City of Richmond
Urban Development Division

Report to Committee

RZ 04-266049

Re: **APPLICATION BY CENTURY HOLDINGS LTD. FOR REZONING AT 7571 AND 7611 ALDERBRIDGE WAY FROM LIMITED INDUSTRIAL RETAIL DISTRICT (I4) TO DOWNTOWN COMMERCIAL DISTRICT (C7)**

FOURTH FLOOR PLAN
 SCALE: 1/8" = 1'-0"

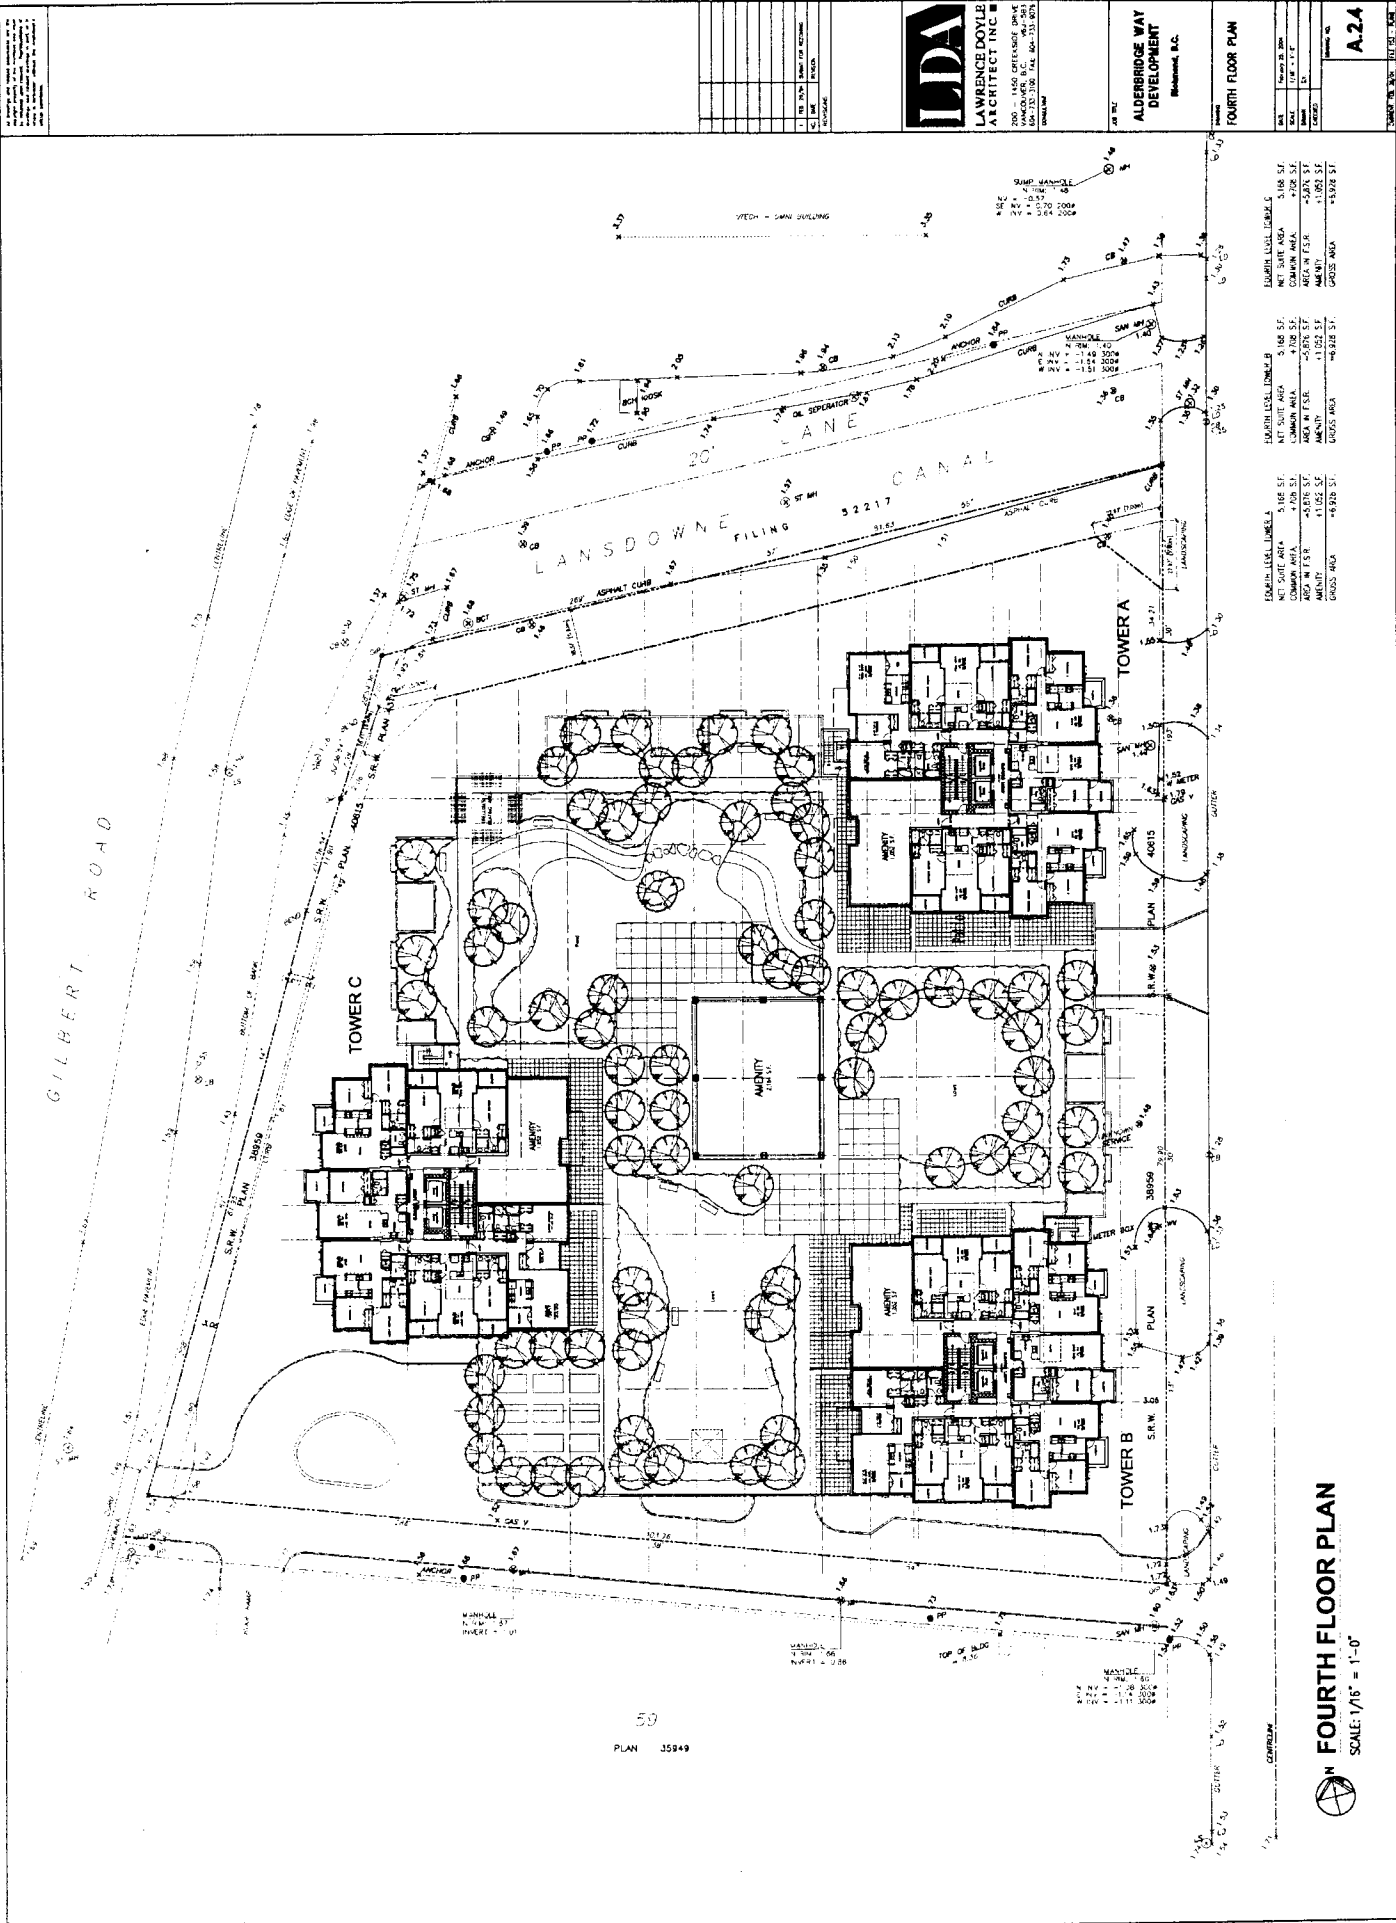
- The gate on the parking garage entry on Alderbridge should be recessed at least 15 m (49 ft.) from the property line to minimize queuing across the sidewalk.

- d) Rear Service Lane –
 - The lane will be used for both service purposes and as a primary pedestrian and vehicle entry to the project and, as such, it should be designed to City Centre standards, including a sidewalk and street lights. (A second sidewalk will be installed by others on the south side of the lane when the neighbouring site redevelops.)

- Space must be provided along the lane to accommodate large moving trucks without impeding other vehicles, and it must be demonstrated that large vehicles will be able to enter and exit the lane safely (or additional widening may be required).

- The building frontage along the lane should incorporate CPTED principles, attractive and durable materials, green landscaping, and other measures that will enhance pedestrian amenity and visual interest. In addition, planting, landscape features, and special paving treatments should be incorporated into the proposed turn-around to enhance its appearance.

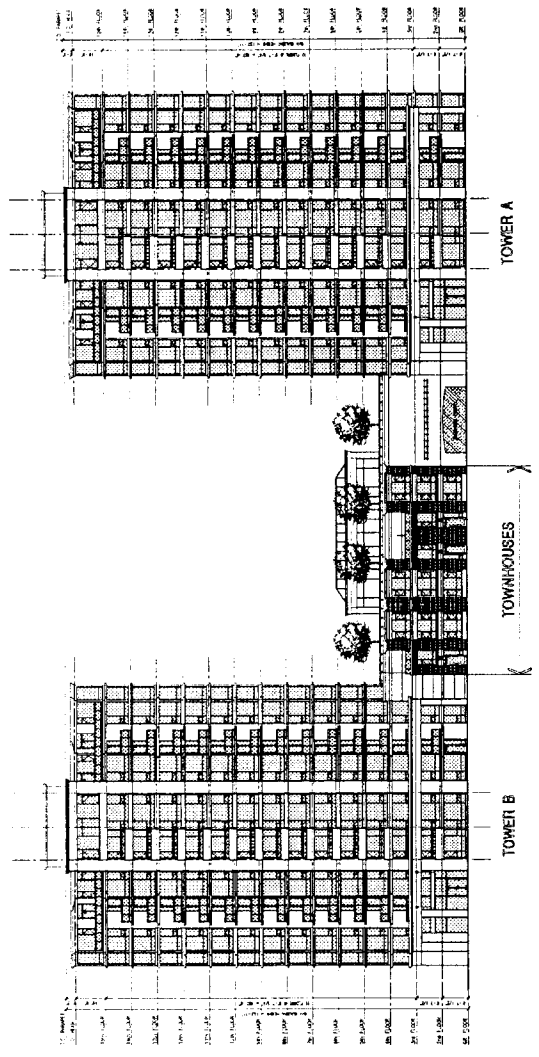
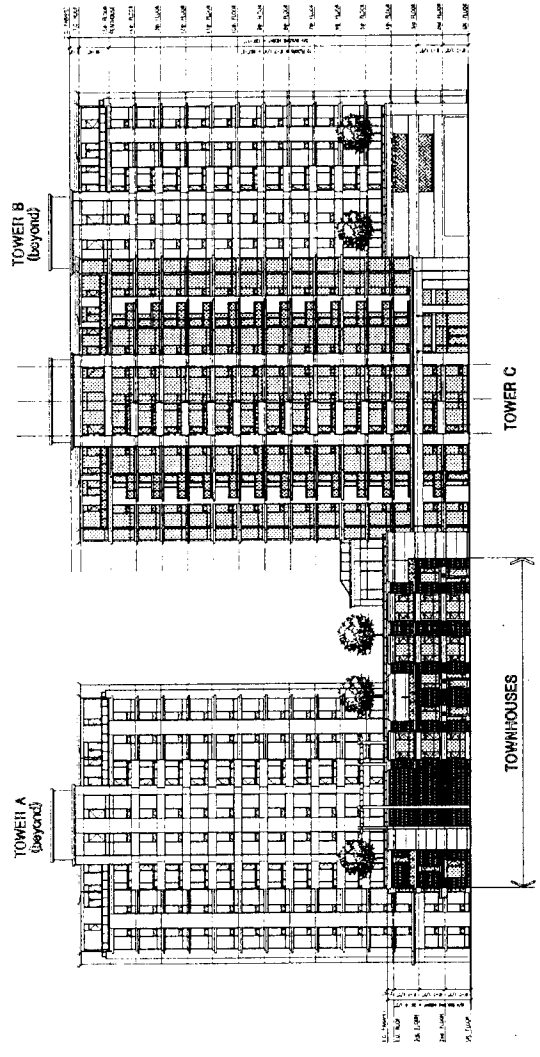
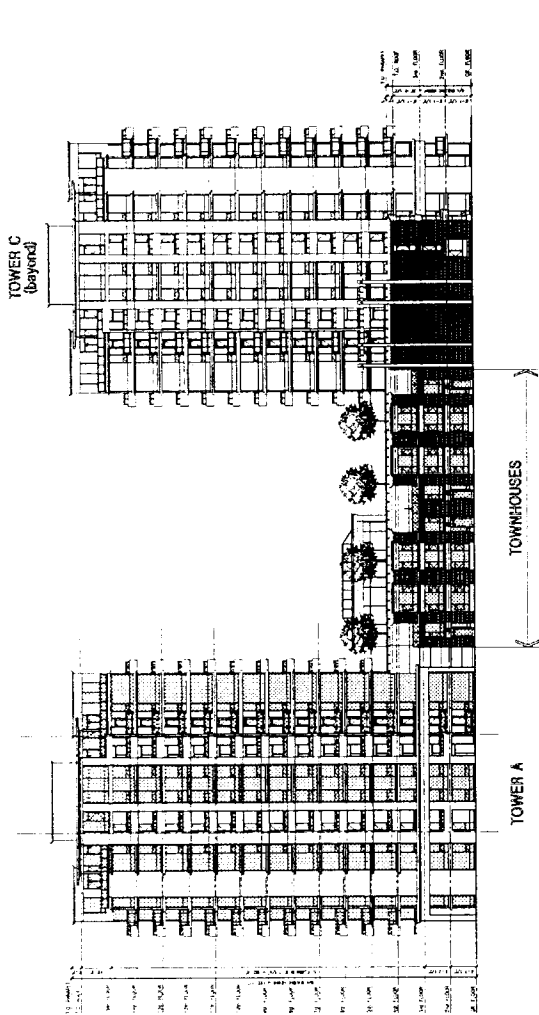
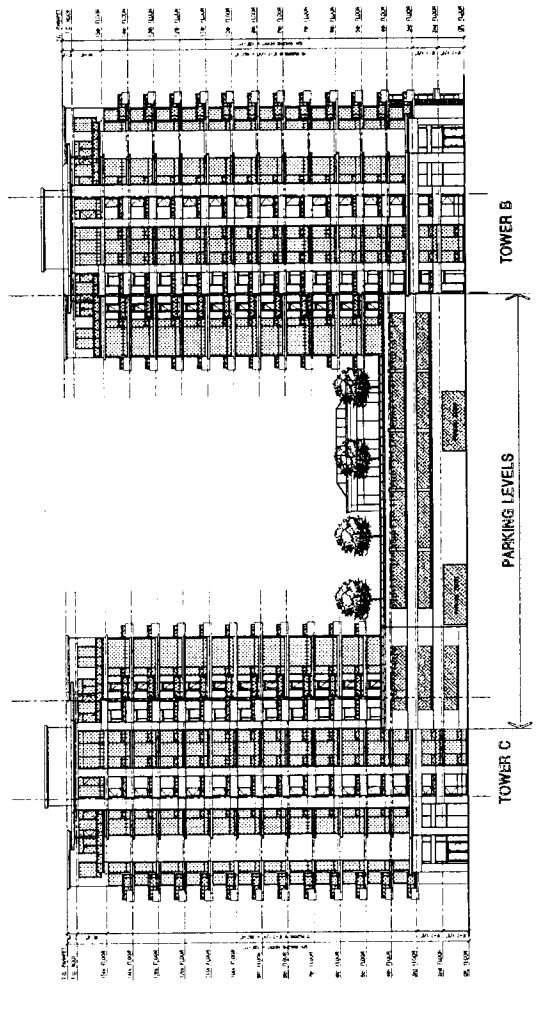
- Note that “work/live” dwellings, rather than conventional townhouse units, are encouraged along the project’s frontages.
- Variations should be introduced into the design of the three towers to enhance the project’s visual interest and the downtown skyline.

- With regard to form of development, the role of each of the three streets bordering the subject site and the rear lane are different and the design of the proposed building should respond to this and enhance it:

- a) Gilbert –
 - Gilbert should be developed as an important “gateway” to the City Centre and an attractive north-south pedestrian link between the downtown and the riverfront.

- The Gilbert frontage should be a combination of bold architectural features (i.e. attractive, glass-enclosed building lobbies, work/live units with a distinctive character, etc.), and generous landscaping (i.e. a double row of trees framing a 2.5 m/8.2 ft. min. wide sidewalk, decorative planting, water features, etc.) arranged to take advantage of Gilbert’s curvilinear alignment that gives the street an informal feeling and provides for unusually sweeping views.

- Special attention should be paid to the prominent Lansdowne/Gilbert corner. Staff recommend that the design of this location, in particular, include a significant public art piece, as per Richmond’s Public Art Program (e.g. valued at approximately \$0.60/ft² of buildable area), together with pedestrian weather protection, seating, and other amenities.

- b) Lansdowne –
 - Lansdowne will be a major east-west artery and an important greenway route linking the downtown with the riverfront.
 - The Lansdowne frontage should be more urban and formal than that along Gilbert, and should be designed to enhance the street’s intended pedestrian role through the use of work/live units with individual entries along most of its length, opening onto a 2.5 m/8.2 ft. min. wide sidewalk lined with a double row of street trees, and framed by the afore mentioned public art feature at Gilbert and an attractive, glass-enclosed building lobby at Alderbridge. Pedestrian weather protection is encouraged.

- c) Alderbridge –
 - Alderbridge will be similar to Lansdowne in its role and prominence, but its character should be somewhat more urban.
 - As for Lansdowne, work/live units are encouraged along most of the length of the Alderbridge facade, framed by building lobbies at corners, and opening onto a 2.5 m min. wide sidewalk lined with a double row of trees. The work/live units should, however, have a more urban character. Preferably, this should include more hard landscaping along the street front, little if any private outdoor areas at grade, and continuous pedestrian weather protection.
